complete guitar wiring: erratum

Gibson Explorer

correction

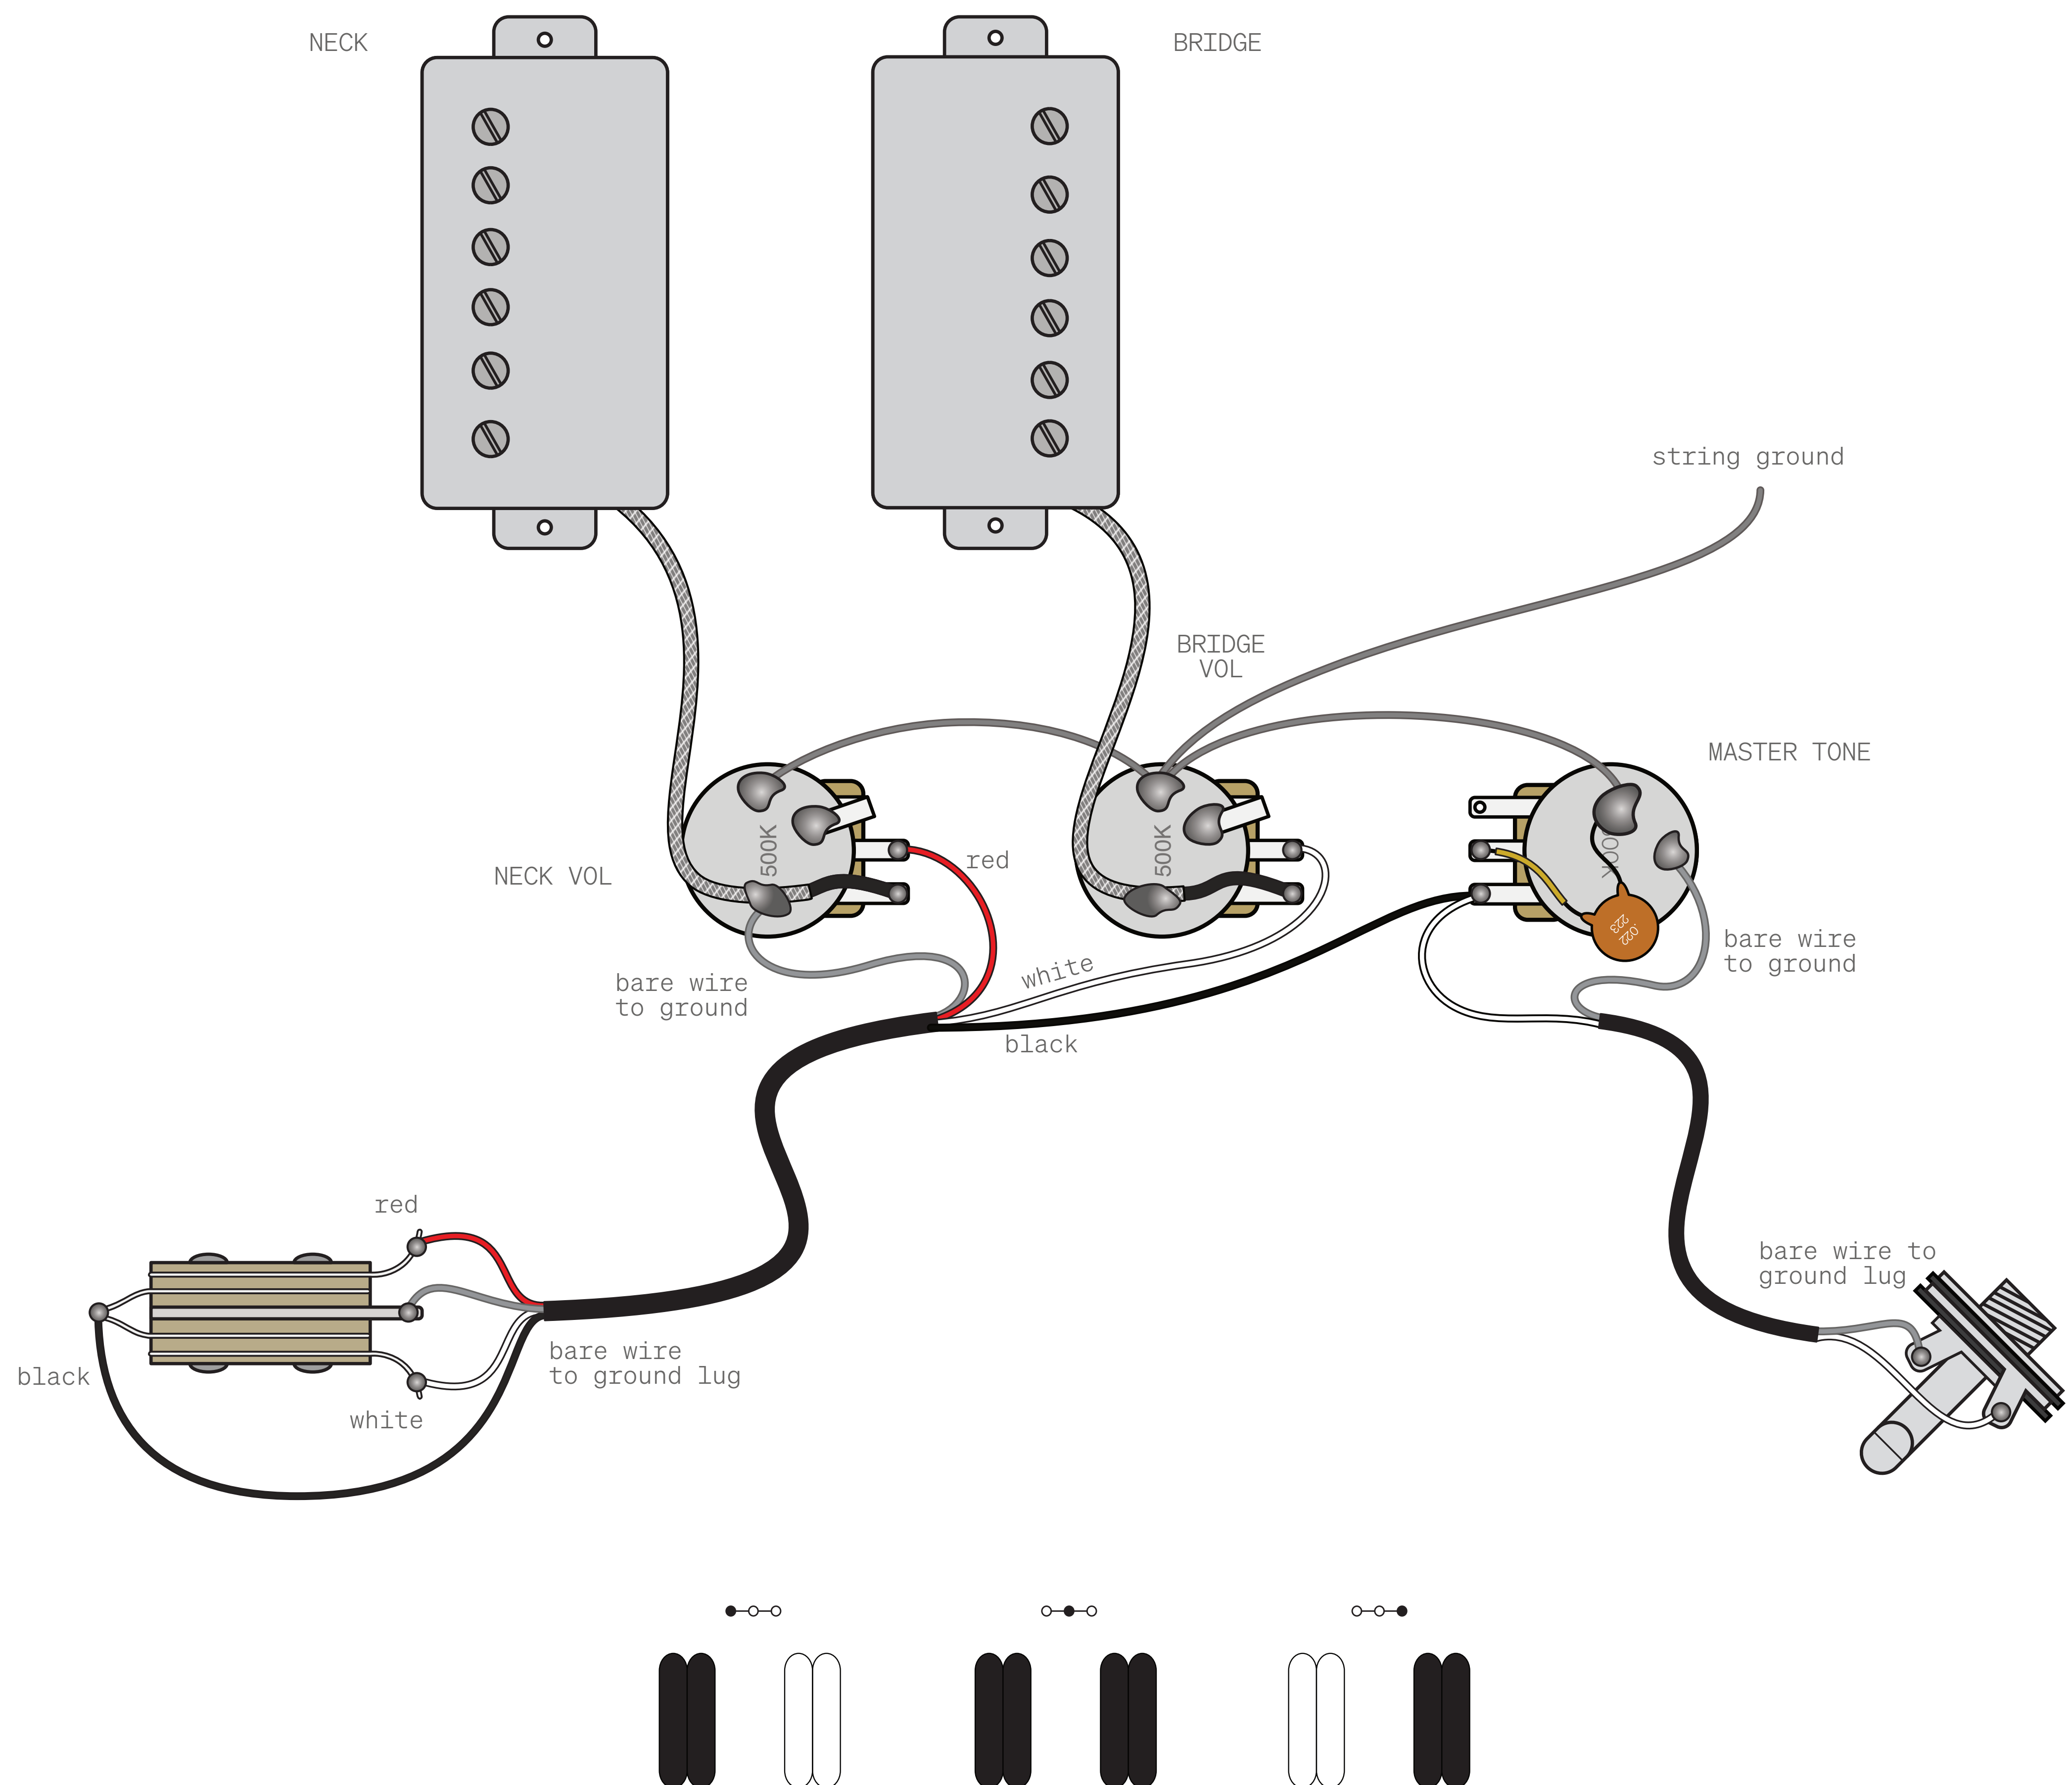
Page 252. Original diagram showed pots in reverse order with neck volume at right. Depicted wiring was sound but pot position incorrect.
